Renewal of Martinborough Wastewater Treatment Plant (MWWTP) Consents

Brian Coffey revised 03 November 2015 [and reviewed by Olivier Ausseil 16 December 2015](#)

Figure A: *Engineered High Flow Back Channel that has recently been constructed downstream of the MWWTP by Greater Wellington Regional Council.*

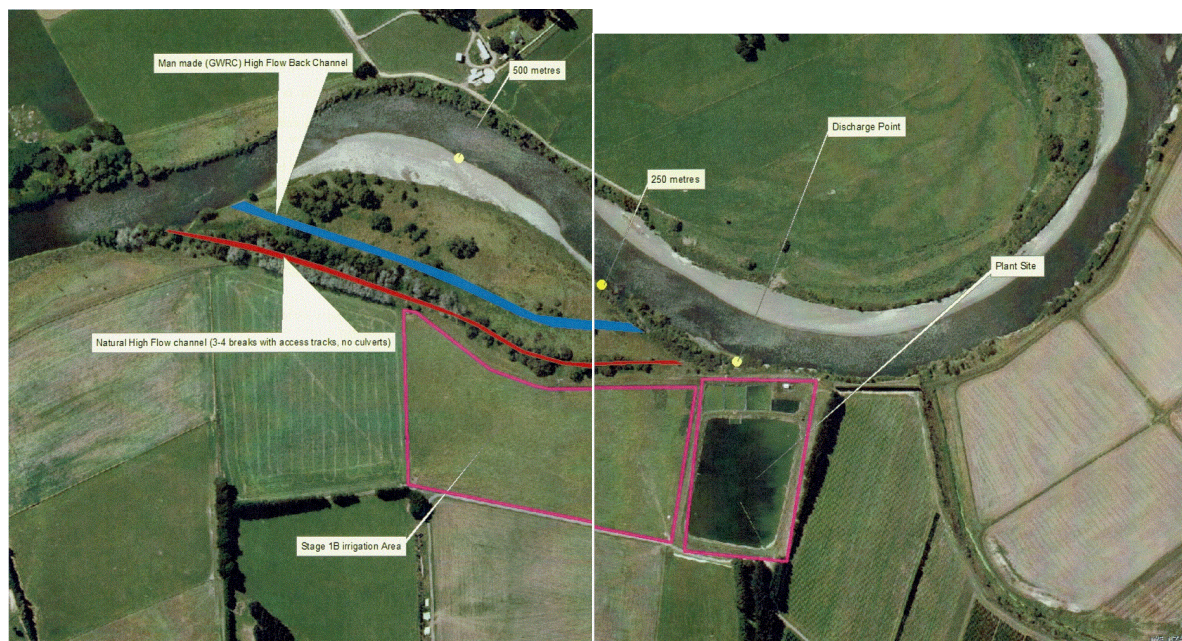
- 26A Fencing shall exclude stock access to the left bank of the Ruamahanga River between the MWWTP and the western side of the natural high flow channel to the west of the MWWTP (as shown in Figure a) for the duration of Stages 1A, 1B and 2A.
- 26B Stock water shall not been drawn from the Ruamahanga River between the MWWTP and the western side of the natural high flow channel to the west of the MWWTP (as shown in Figure a) for the duration of Stages 1A, 1B and 2A.
- 26C Fencing shall exclude stock access to additional storage pond(s) for treated wastewater following the commissioning of the Stage 2B upgrade of the MWWTP.

It is understood that only greater than normal river flows (i.e. >50 cumecs as measured at Waihenga) will enter the engineered high flow back channel on the left bank of the Ruamahanga River as shown in Figure A.

However, a proportion of any discharge from the MWWTP to the Ruamahanga River that occurs at river flows in excess of 50 cumecs may be entrained in the engineered high flow back channel and enter the Ruamahanga River downstream of the 500 m site shown in Figure A.

Indeed, given the locality of the intake for the engineered high flow back channel, most of the discharge from the MWWTP to the Ruamahanga River that occurs at river flows in excess of 50 cumecs would be expected to enter the engineered high flow back channel and discharge to the Ruamahanga River downstream of the 500 m site shown in Figure A.

The worst case scenario for river discharges from the MWWTP expected during Stage 1B and Stage 2A upgrades will be for river flows between half median and median river flows (25 to 50 cumecs) and these effects can be measured in the mainstem of the river when no flow will be diverted through the engineered high flow back channel.

If, as expected, the proposed river monitoring programme following the Stage 1B upgrade showed no significant adverse instream effects of the half median to median flow discharges that did occur from the MWWTP, no further concern would exist for MWWTP river discharges that occurred at river flows above median flow that might enter the engineered high flow back channel.

Conversely, if there were significant adverse effects associated with half median to median flow discharges from the MWWTP that did occur following the Stage 1B upgrade, the requirement for post Stage 1B instream monitoring could be re-visited at that time.
